DINENSION ARE MILLIMETERS	SCALE	8 / 1	REV	C	UNIT	MM	JYE BAO CO., LTD. TAIPEI TAIWAN
UNLESS OTHERWISE SPECIFIED TOLERANCES	APPROVE					DATE	
0~20 = ±0.03	CHECKED					DATE	FERRULE
20~50 = ±0.05	DRAWN					DATE	DRAWING NO.
50~ = ±0.10							BNC3100-0059-9

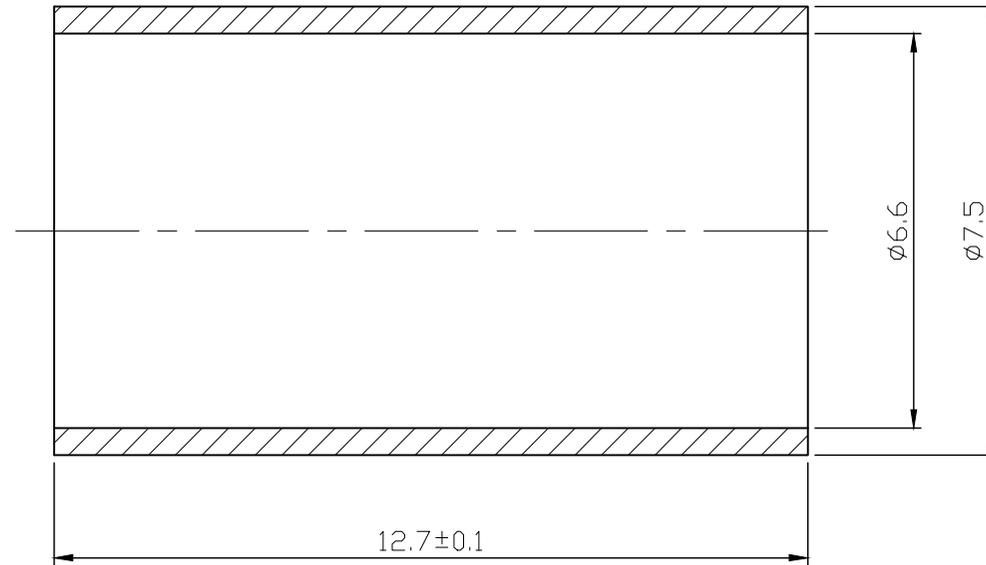
REVISION			
REV.	DESCRIPTION	DATE	APPROVED
C	增加熱處理,材質改COPPER 總長度放寬公差為±0.1	10/09/97"

※熱處理：高溫爐加熱至550°C,爐冷.

MATERIAL : COPPER.
